Vieux Carré Commission Architecture Committee Meeting

Tuesday, April 9, 2024

Architecture Committee Meeting of 04/09/2024

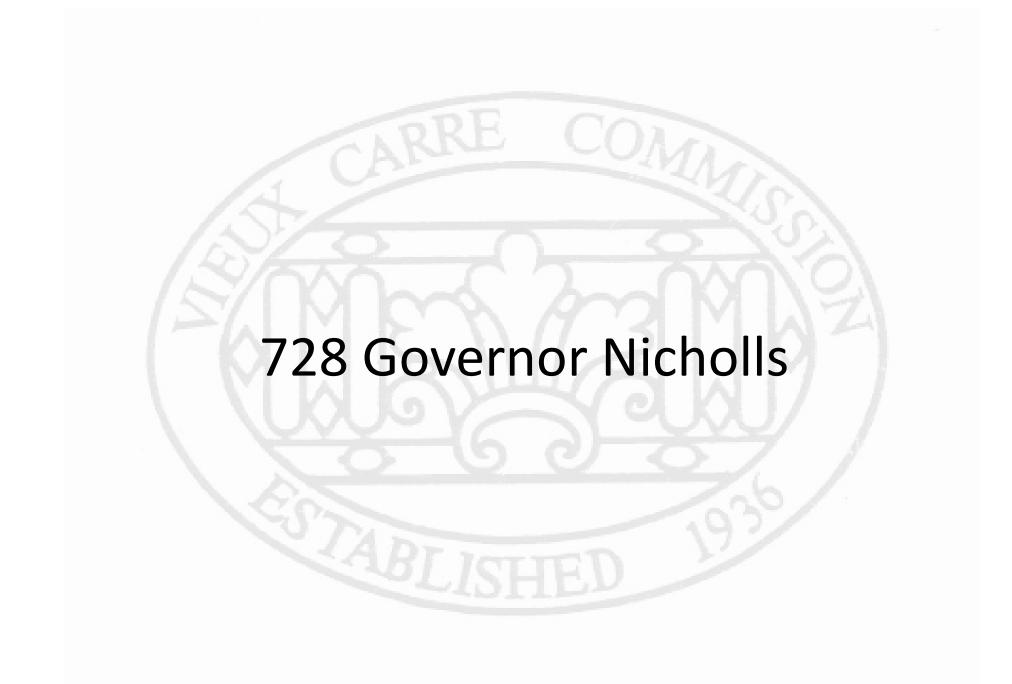
Staff visited the site and established that the platform will have no visibility from the public right of way. If approved, there will be limited visibility from one neighboring property and a privately owned parking area. Another adjacent property will likely have a more direct view of the equipment, but screening could be approved for the side elevation that would obscure it from all three of these locations.

As a reminder, the fourth unit is proposed to be located at the end of the service ell balcony, to replace an existing condenser that surprisingly was approved by the VCC in 1992. The Guidelines typically prohibit the installation of mechanical equipment on balconies or galleries, and it is not clear from the meeting records why this property was considered an appropriate exception.

Staff notes that the courtyard at this property is large and there is ample space for mechanical equipment at grade. However, staff finds the proposed revisions to the platform to be a significant improvement over the previous proposal, and seeks the guidance of the Committee regarding its approvability. If found conceptually approvable, Commission review is also required for the rooftop installation of mechanical equipment and a roof hatch. Screening details and flashing details where the platform meets the roof will need to be submitted for review at staff level prior to permit.

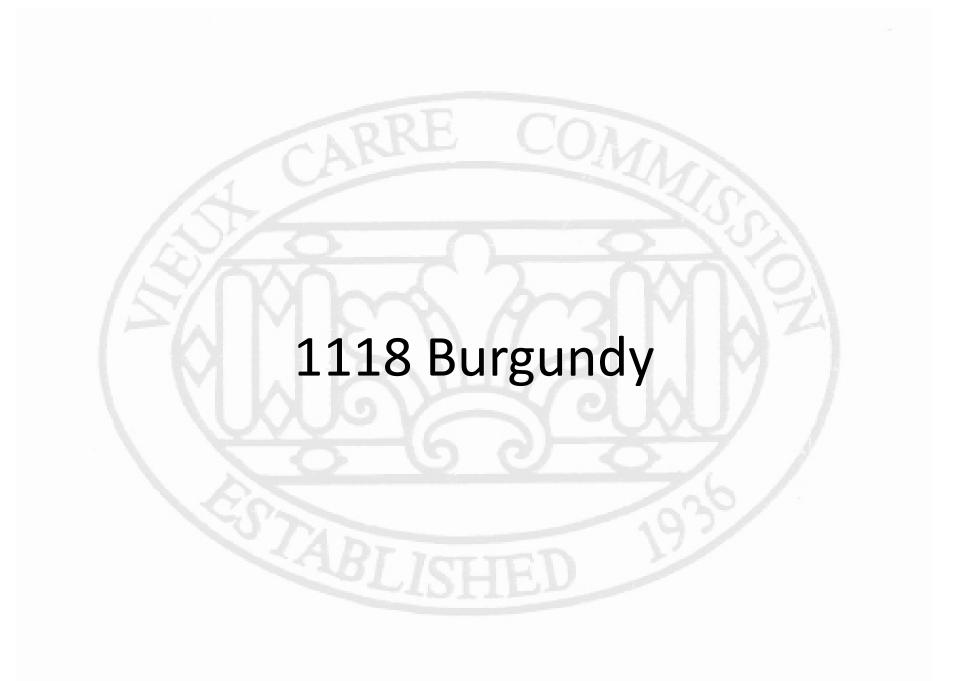
The applicant has submitted revised plans following Committee review on 12/05/2023. Notable items are as follows: [keynotes correspond to drawings submitted]

- 15: a paving plan and section have been provided for the courtyard and alley, showing 1-1/2" thick flagstone pavers with silicone filler on a 3/8" setting bed over a 4" concrete slab. Staff notes that a limited amount of the open space can be impermeable per the CZO, even in the French Quarter. This should be confirmed with Zoning, as it is likely that the flagstone will have to be installed on a permeable bed. [Staff notes that silicone filler is not appropriate for this detail if impermeable pavers end up being allowed.] Staff recommends **deferral**, with final review of details to be handled at staff level.

- 1 & 3: the courtyard fence will be capped, and the gate replaced with a new wood gate to match previously existing. Staff finds both **conceptually approvable**.

- 9: three large electrical conduits installed without permit will be relocated to the inside corner of the balcony where it meets the wall, and will be painted to match. Lighting will be replaced with recessed fixtures on the second floor and can lights on the first floor. Staff notes that locations of the fixtures are approvable but the size (no larger than 3" dia. by 7" long) and lamping (3000K color temp required) of the can lights are not. Revisions can be handled at staff level. Three electrical panels are labeled as abandoned, but are not noted for removal. Any abandoned panels, fixtures, and/or wiring must be removed. Staff finds the proposed lighting plan **conceptually approvable** with revisions to be submitted as noted.
